# CITY OF GARDEN CITY

**File Number: DSRFY2021 - 0007**  
**Application Scope: Design Review Hearing for a Service Provider**  
**Location: 4980, 4961, and N. Bradley Street**  
**Applicant: Joe Turner**  
**Report Date: February 7, 2022**

Staff Report  
 Prepared by Hanna Veal

Figure 1: Ada County Assessor's Parcels Owned By Western Heating and Air

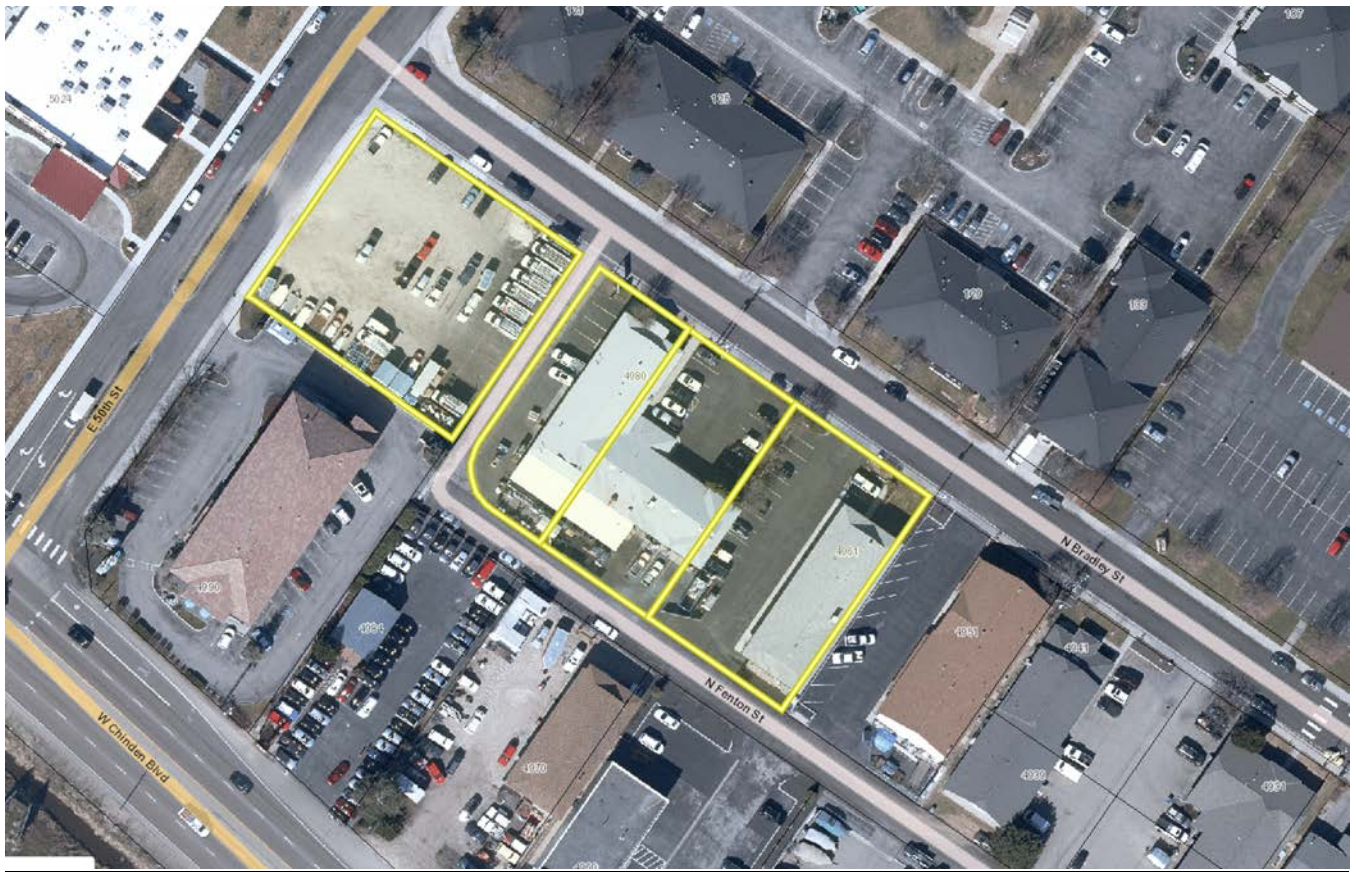
As there are a number of adjacent properties that Western Heating and Air is utilizing as a single business, staff suggests that it is reasonable to review the properties that constitute the site as a part of this review. ([Figure One](#))

<b>Garden City Title 8 Code Sections</b>			
Code Section	Review Authority	Compliance Issues	Analysis/ Discussion
<b>Title 8, Chapter 1: General Regulations</b>			
<a href="#">8-1A-4 Applicability</a>			The regulations of Garden City Code, Title 8 Development Code of the City, shall apply and govern development and use of all properties within the corporate limits of the city.
<a href="#">8-1B-1 Nonconforming Properties</a>		No compliance issues noted	The site consists of lots 6, 7, and 8 of Bradley Field Business Park Subdivision. All of which appear to be described as legal lots of record.
<a href="#">8-1B-2 Nonconforming Structures</a>		May not be complaint – Compliant as conditioned	It appears that the site consists of three lots of record. The existing structure and the proposed expansion are and will be crossing all three lot lines. A lot line adjustment shall be required and has been made a drafted condition for approval.  There was a Record of Survey submitted with this application, dated 09-02-2020, however there is not a City Engineer Signature on the ROS to determine that it was legally recorded with the City. Ada County Assessors website shows that the eastern most property boundary line to run through a section of the building, causing the building encroachment into Lot 6. <a href="#">(Figure One)</a>
